**DEPARTMENT OF PLANNING AND ZONING
PLANNER'S REPORT**

DATE: August 14, 2019
 TO: Tonya Hutson
 FROM: Lynn Patterson
 RE: **Design Review – 600 South Central Avenue ATM Addition**

TOP VIEW
SCALE: 1/2" = 1'-0"

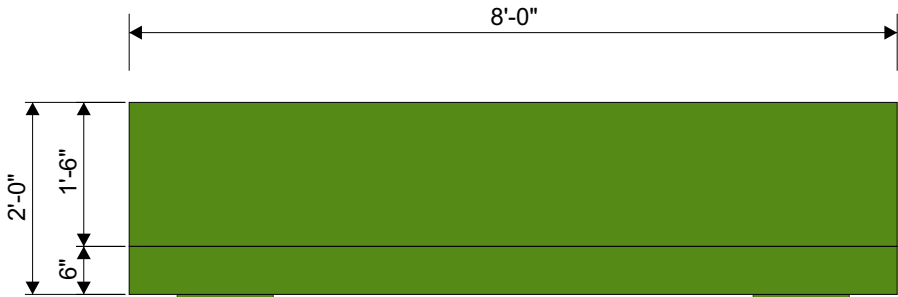
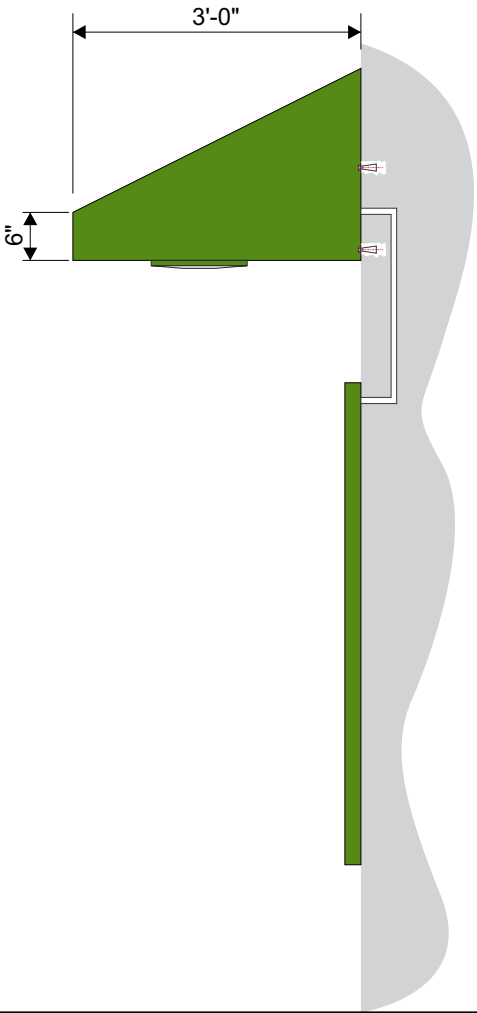
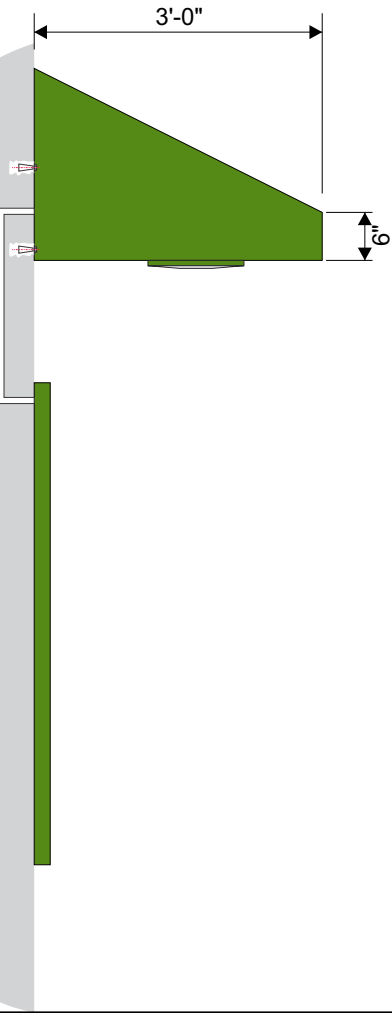
NOTES: Awnings must be 5' deep. The proposed awning above the ATM is 3' deep, which is not compliant and will require a design exception

PROPOSED ELEVATION

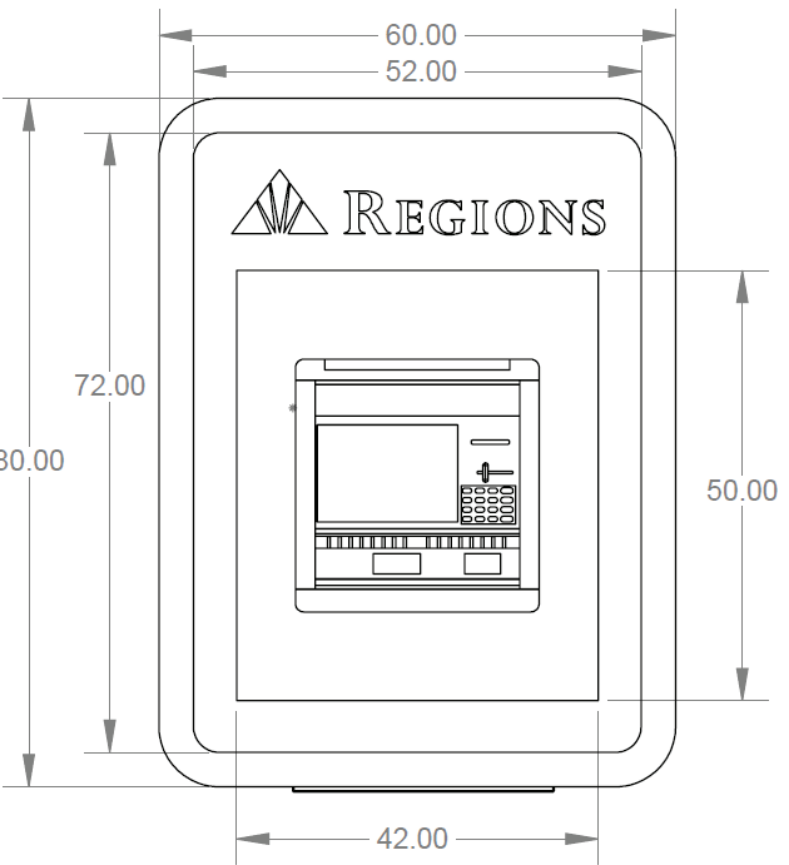
Drive-throughs shall not be visible from the public right-of-way. The existing drive-through lane window is visible from the right-of-way, as would be the proposed ATM and awning, which is not compliant and will require a design exception. A design exception will also be required to allow the provided awning to be less than 5' deep.
